Crystal River Nuclear Plant  
Docket No. 50-302  
Operating License No. DPR-72

**Subject:** Crystal River Unit 3 – License Amendment Request #290, Revision 1  
Probabilistic Methodology to Determine the Contribution to Main Steam Line Break Leakage Rates for the Once-Through Steam Generator from the Tube End Crack Alternate Repair Criteria

**Response to NRC Request for Additional Information (RAI)  
Regarding License Amendment Request #290, Revision 0**

# CR3 OTSG ACCIDENT-INDUCED (MSLB) PRIMARY-TO-SECONDARY LEAKAGE LIMITS SIMPLIFIED DIAGRAM (PER OTSG)

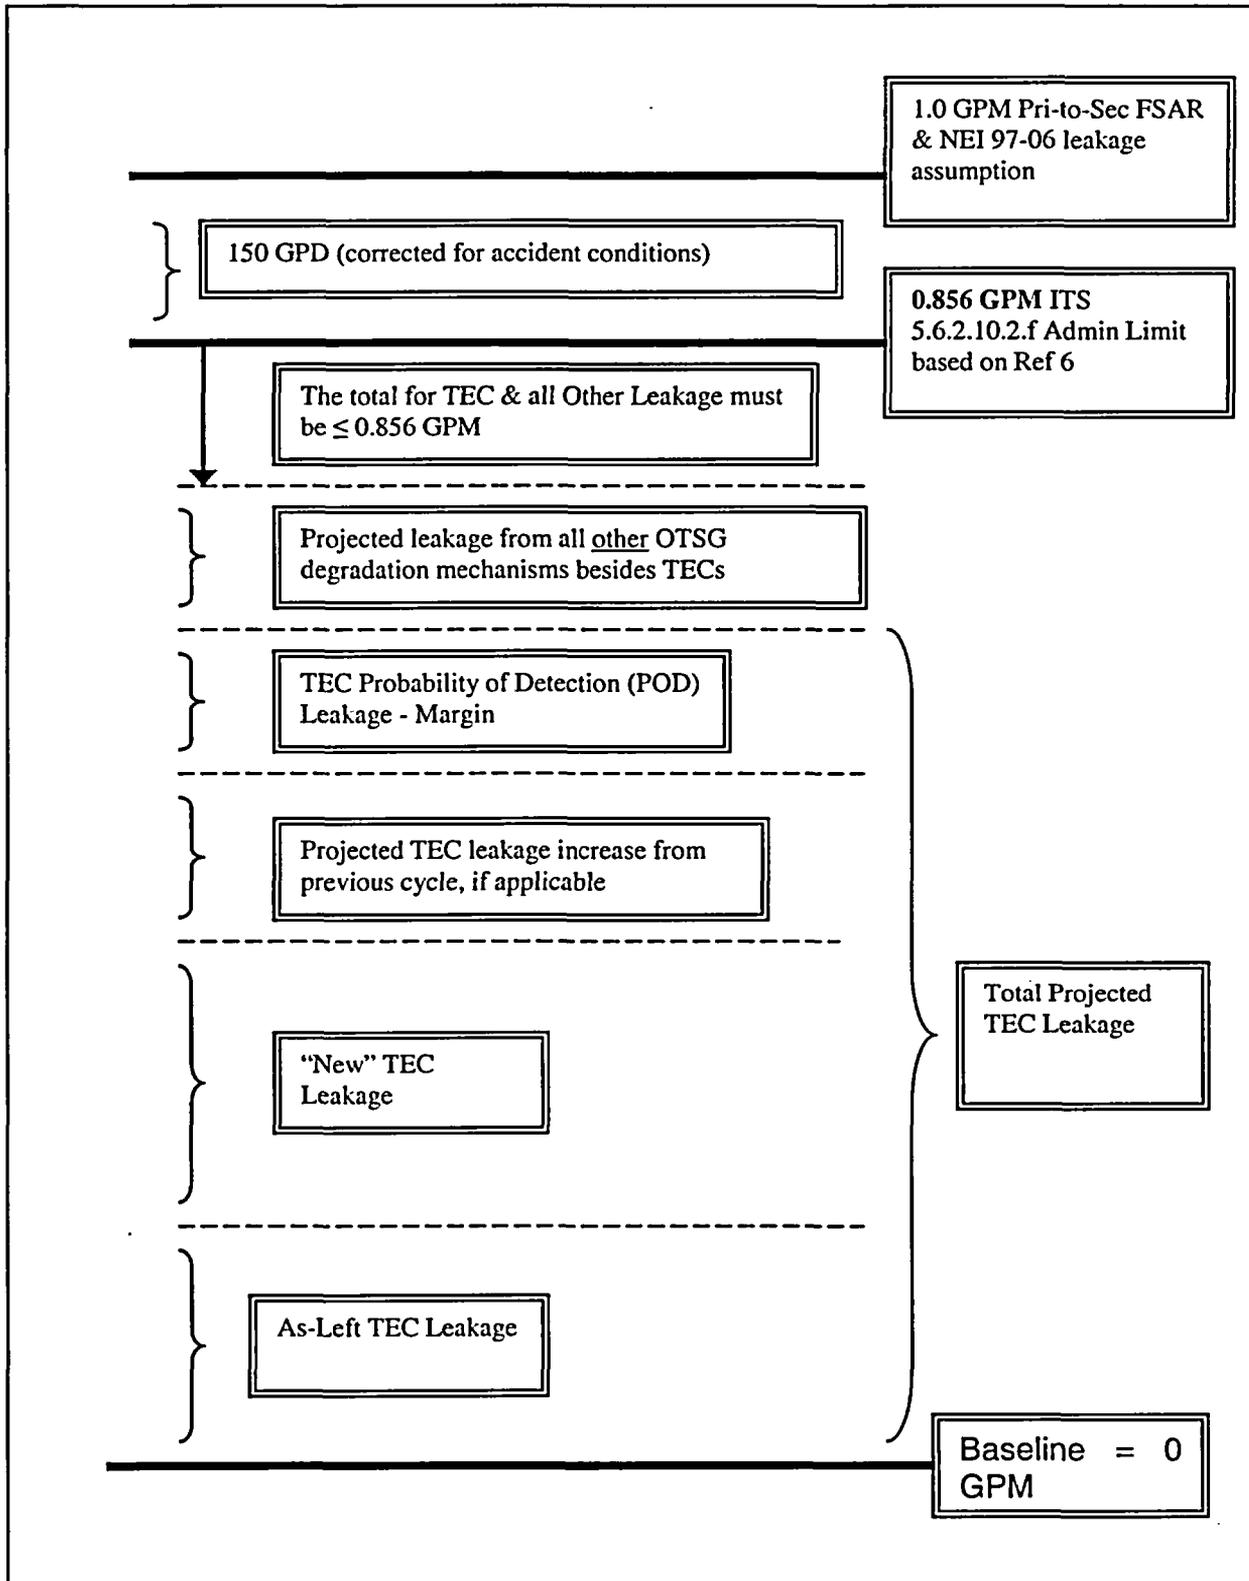
**Note 4** – To account for a TEC increasing leakage trend, an additional amount of TEC leakage needs to be added above the previous cycle “new” TEC leakage **IF** there is any recent increasing new leakage trend. The use of a linear extrapolation method using the changes in New TEC leakage was selected as the way to project potential increases in the TEC leak rates. See Enclosure 1 for a description of why this method was chosen. Linear extrapolation involves comparing the “new” TEC leakage from the previous two operating cycles. For example, determine the  $14R_{As-found \text{ TEC leakage}} - 13R_{As-left \text{ TEC Leakage}}$  new TEC leakage and compare to the  $13R_{As-found \text{ TEC leakage}} - 12R_{As-left \text{ TEC Leakage}}$  new TEC leakage. If the most recent operating cycle “new” TEC leakage is less than the previous “new” TEC leakage, then there is no apparent increase and this amount is 0.0 gpm. This means that a decreasing trend cannot be used to provide a leakage credit.

However, if the most recent operating cycle “new” TEC leakage is greater than the previous “new” TEC leakage, then the leakage difference between the two operating cycles should be added to the projection. As examples, if the 13R new leakage was 0.45 gpm and the 14R new leakage is 0.45 gpm than no increasing leakage trend is apparent and no additional leakage amount is applied to this parameter. Conversely, if the 13R new leakage was 0.40 gpm and the 14R new leakage is 0.45 gpm than an increasing trend may be developing. In this case, an additional leakage amount of 0.05 gpm  $(0.45 - 0.40)$  should be added to the projected leakage. The equation for this process is  $(14R_{new \text{ leakage}} - 13R_{new \text{ leakage}}) = \text{Increase Leakage Amount}$ . To account for the possibility of a continuously increasing trend that deviates from the expected steady or decreasing growth rates observed in Figure 2, also compare the new leakage values for the 12R new and 13R new leakages. If the new leakage from 13R was greater than the new leakage from 12R, then determine that difference. If the 13R-14R increase is larger than
